SECOND CHANGE APPLICATION REPORT

Drax Bioenergy with Carbon Capture and Storage

Document Reference Number: 8.15

Applicant: Drax Power Limited

Plate 2-1 - Extract from Current Land Plan for OHL1 Works – Plan 2.2 – Rev P02, Sheet 03

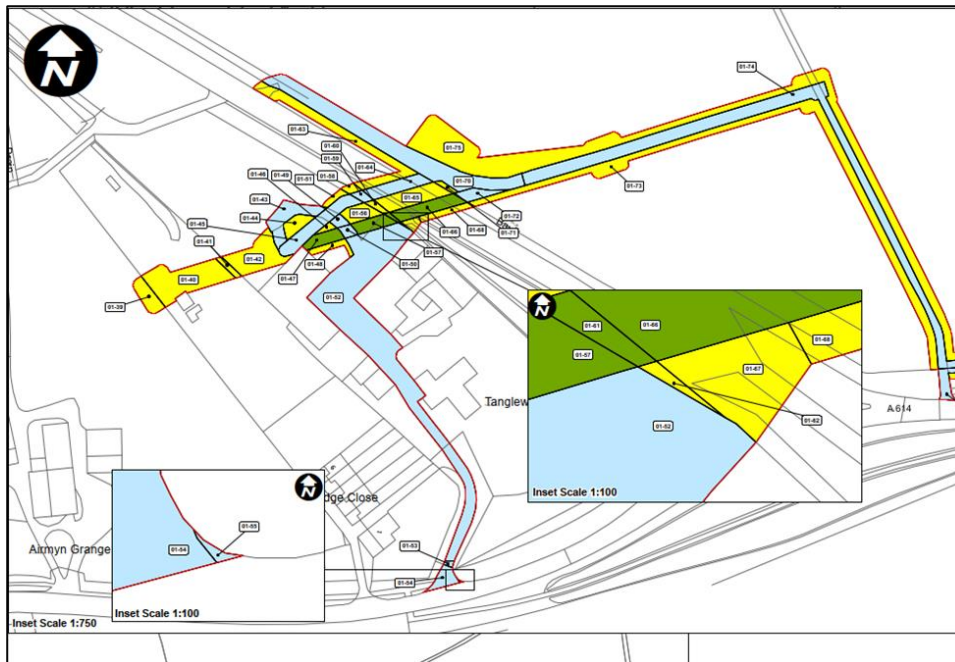
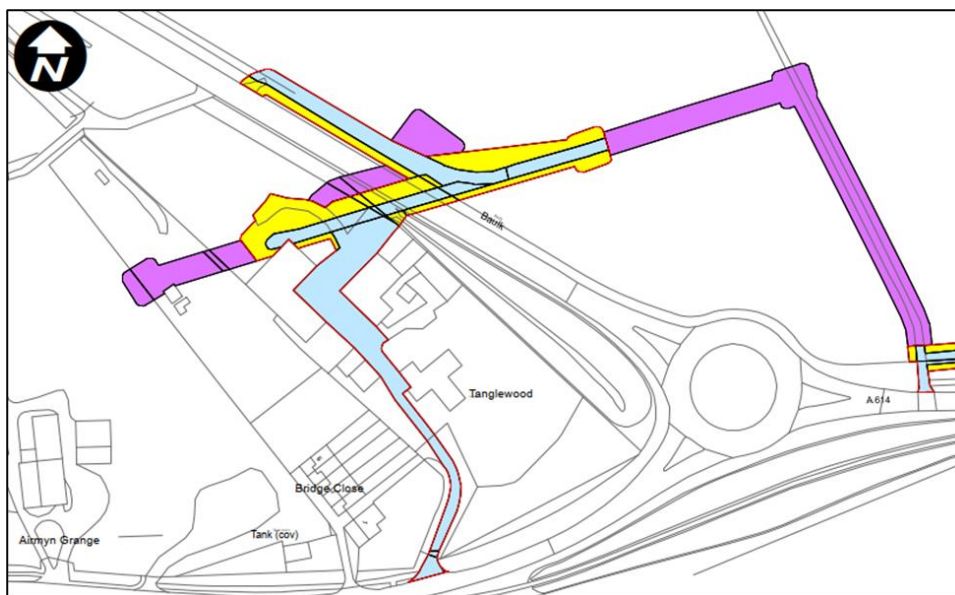
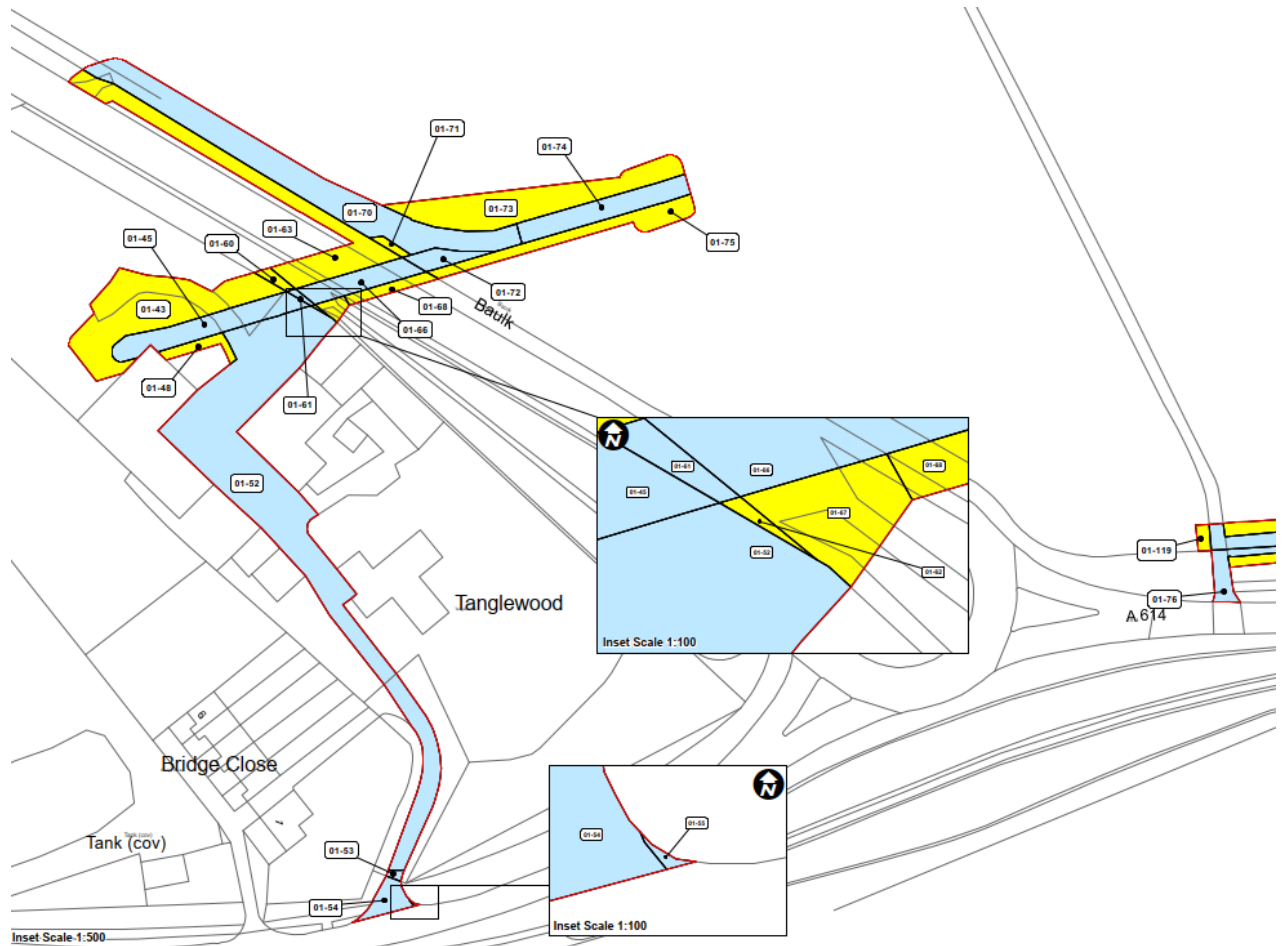
- 2.2.1. OHL1 is an existing electrical overhead line which crosses the A645. Sheet 3 of the Land Plans shows the areas of land affected by works for OHL1 (west and east of the A645). Below are extracts from the currently submitted Land Plans and extracts illustrating the proposed changes. The land identified in purple is no longer required for works and it is proposed to remove this land from the Order Limits. It can also be seen that the areas of land previously proposed to be subject only to extinguishment of rights powers, is now sought to be subject to compulsory acquisition of rights powers.

- 2.3.1. The asset owner, Northern Powergrid’s preferred design for the works has confirmed that undergrounding via a trenchless installation method such as Horizontal Directional Drilling (HDD) is not feasible due to other utility assets in the locality, and that the installation of the undergrounded section of the electrical cable would be via an open trench installation method across the highway only. The asset owner has confirmed that it would prefer to retain the overhead line in its current alignment with the only undergrounded section being across the highway also following the alignment of the existing overhead line within a 10m wide corridor to provide flexibility to adjust the exact routing to navigate around existing infrastructure in/under the

highway. To facilitate this solution, it is proposed that a new wooden pole is installed on the eastern side of the A645, within the verge or as close to the edge of the field as possible, and the overhead line restrung from this new pole to the existing next wooden pole in the line, immediately to the east. This solution means that the works required on land to the east of the A645 for OHL1 (owned by ERYC and currently occupied by Mr Roustoby) are limited to:

- a. the use of the existing access from the eastern edge of the A645 in to the field;
- b. access southwards to the installation location of the new wooden pole;
- c. works to install the new pole;
- d. access between the new pole and the next existing pole to the east to facilitate restrung of a section of the overhead line; and
- e. works from the new wooden pole westwards to install the undergrounded section of the electricity cable via an open trench installation method to the western side of the A645.

- 2.3.2. There would therefore only need to be temporary rights of access to undertake the works, and permanent rights required to facilitate access to, and to maintain and repair the electricity asset in perpetuity.

- 2.3.3. There is no longer a need for land to accommodate the HDD/works compound on the eastern side of the A645, or a requirement to use the existing farm access track from the A614 to facilitate access to existing wooden poles for restrung purposes for OHL1, and therefore these areas of land will be removed from the Order Limits.

- 2.3.4. On land to the west of the A645, the asset owner has confirmed it would prefer to remove the existing wooden pole located immediately to the west of the A645, install a new wooden pole in the same location, and the undergrounded section under the A645 would then end and continue along its existing alignment with a restrung section of overhead line to the next existing wooden pole in the line, immediately to the west. This solution means that the works required on land to the west of the A645 are limited to land owned by Mr Hussain (Tanglewood), and after the installation works described above are completed, the electricity asset would appear very similar to the existing design, with temporary rights of access required to undertake the works, and permanent rights required to facilitate access to, and to maintain and repair the electricity asset in perpetuity.

- 2.3.5. This solution means that there is no longer a need to access land further west of Tanglewood, and therefore the Special Category Land owned by ERYC will be removed from the Order Limits.

- 2.3.6. The solution described above also reduces the amount of land within the Order Limits to remove land no longer required to accommodate a HDD installation of the cable under the A645.

Plate 2-4 - Extract from Current Land Plan for TCL1 Works – Plan 2.2 – Rev 02, Sheet 03

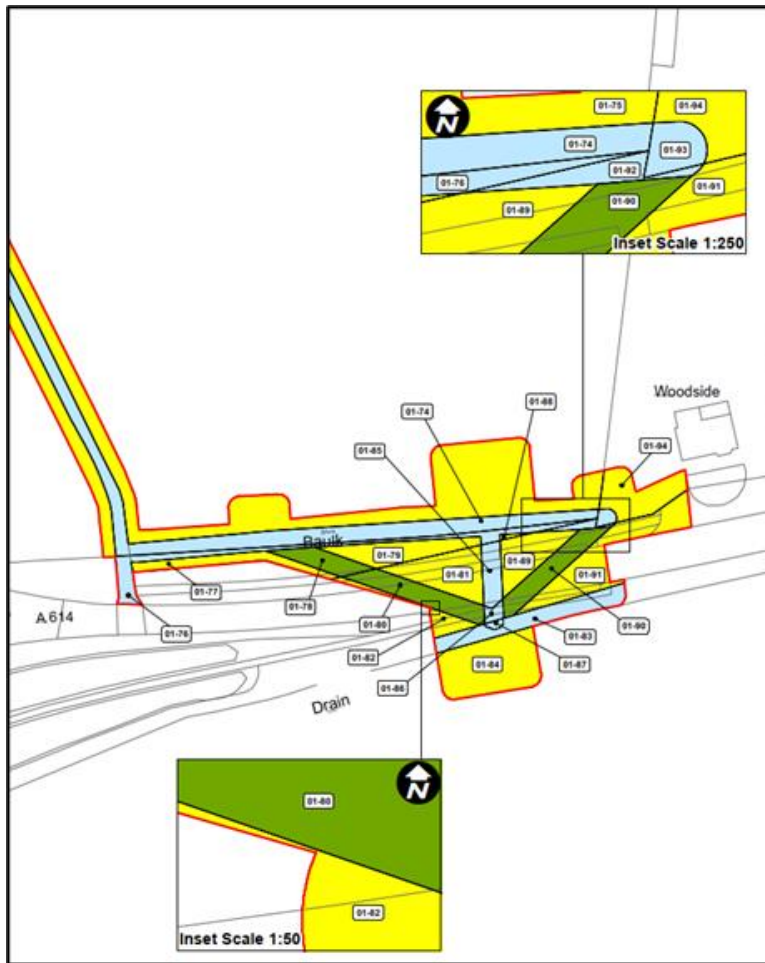
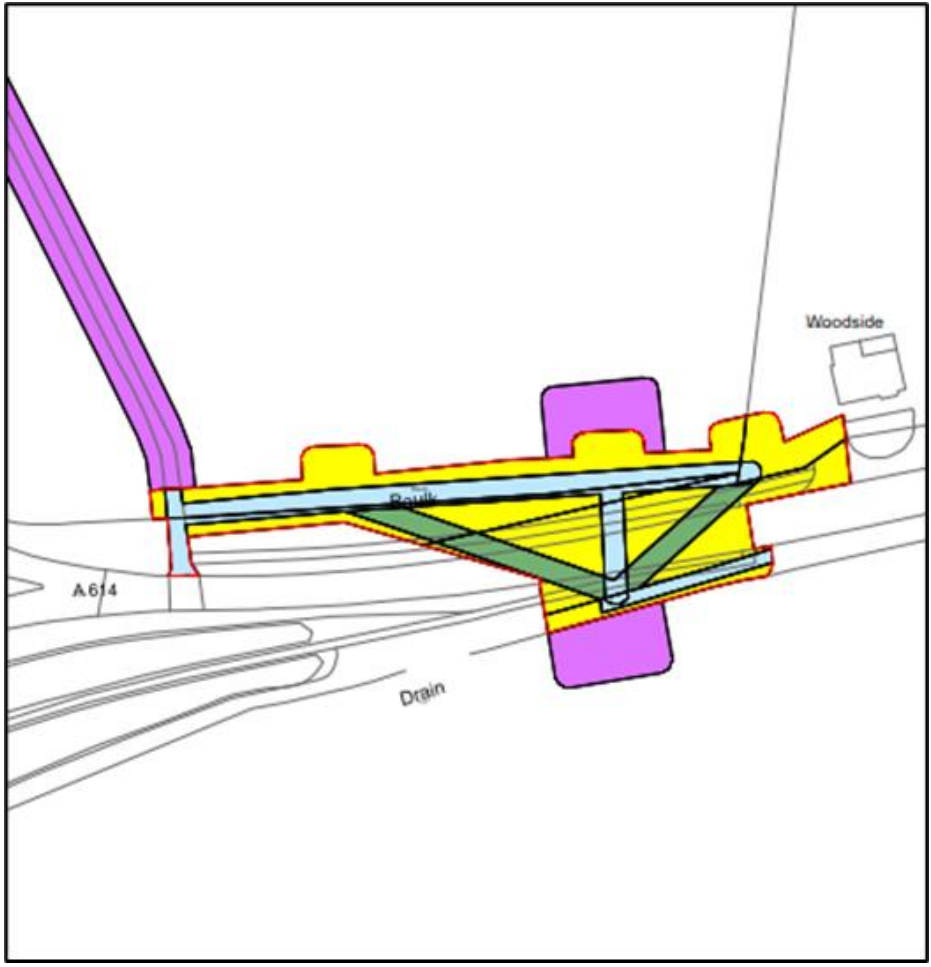
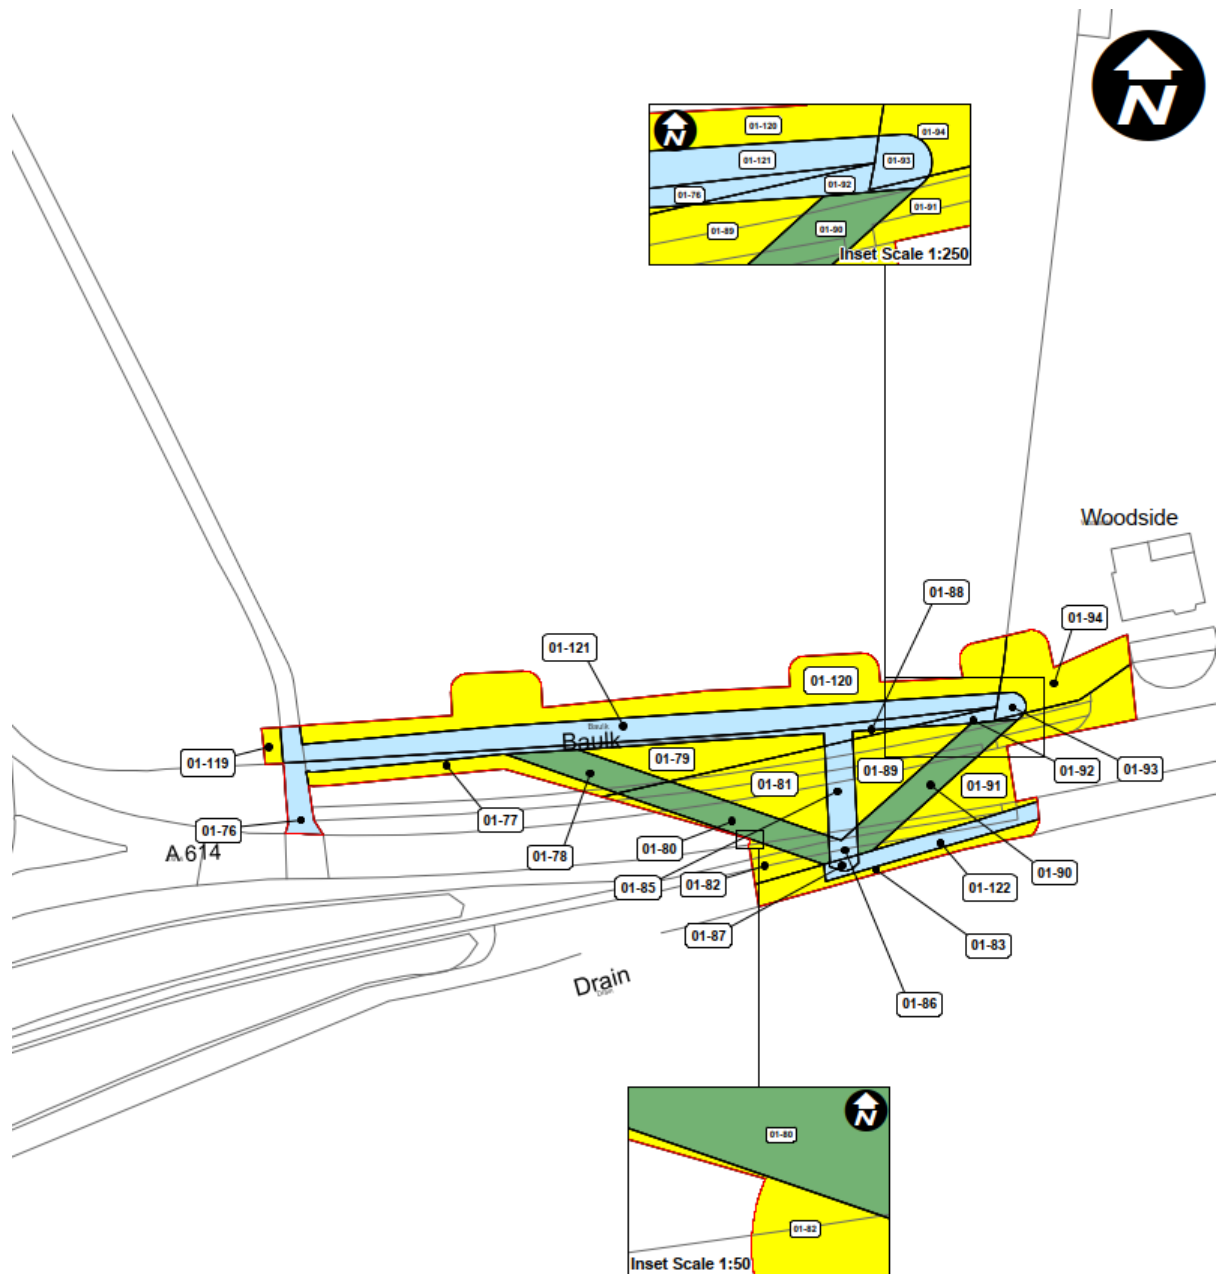
2.2.2. TCL1 is an existing telecommunications line which crosses the A614 twice to the west of Woodside Café. Sheet 3 shows the areas of land affected by works for TCL1 (north and south of Rawcliffe Road). Below are extracts from the currently submitted Land Plans and extracts illustrating the proposed changes. The land identified in purple is no longer required for works and it is proposed to remove this land from the Order Limits. It can also be seen that part of the areas of land previously proposed to be subject only to extinguishment of rights powers, is now sought to be subject to compulsory acquisition of rights powers.

- 2.3.7. The asset owner, BT Openreach, has confirmed that its preferred design to remove conflict with the AIL deliveries would not be to underground the telecommunications line, but instead to replace the existing wooden pole on the southern side of Rawcliffe Road with a taller pole (15m high), install a new wooden pole 15m high on the northern side of Rawcliffe Road opposite the aforementioned pole, and provide a continuous telecommunications line connection between the existing wooden poles immediately to the east of the farm track on the northern side of Rawcliffe Road, on to the new 15m high pole and onwards to the existing wooden pole at the south-western corner of the Woodside Café. The existing telecommunications lines crossing the A614 would be removed, and a new line installed between the two 15m high poles, resulting in the line crossing the A614 once.

- 2.3.8. This solution means that the works required on land to the east of the A645 and north of the A614 for TCL1 (owned by ERYC and currently occupied by Mr Cowling) are limited to:

- a. the use a short section of the existing farm access track from the northern edge of the A614 to facilitate access to the southern edge of the field where the existing wooden poles are located;

- b. access eastwards to the installation location of the new wooden pole;
 - c. works to install the new 15m pole;
 - d. access between the new pole and the existing two poles to the west, and the next existing pole to the east to facilitate stringing of this section of the line; and

- e. access to facilitate the new telecommunications line crossing the A614 to the replaced (taller) pole on the southern side of Rawcliffe Road and the removal of the existing telecommunications line crossing the A614.

- 2.3.9. There would therefore only need to be temporary rights of access to undertake the works, and permanent rights required to facilitate access to, and to maintain and repair the amended telecommunications asset in perpetuity.

- 2.3.10. There is no longer a need for land to accommodate the HDD/works compound on the northern and southern sides of the A614 and therefore these areas of land will be removed from the Order Limits.
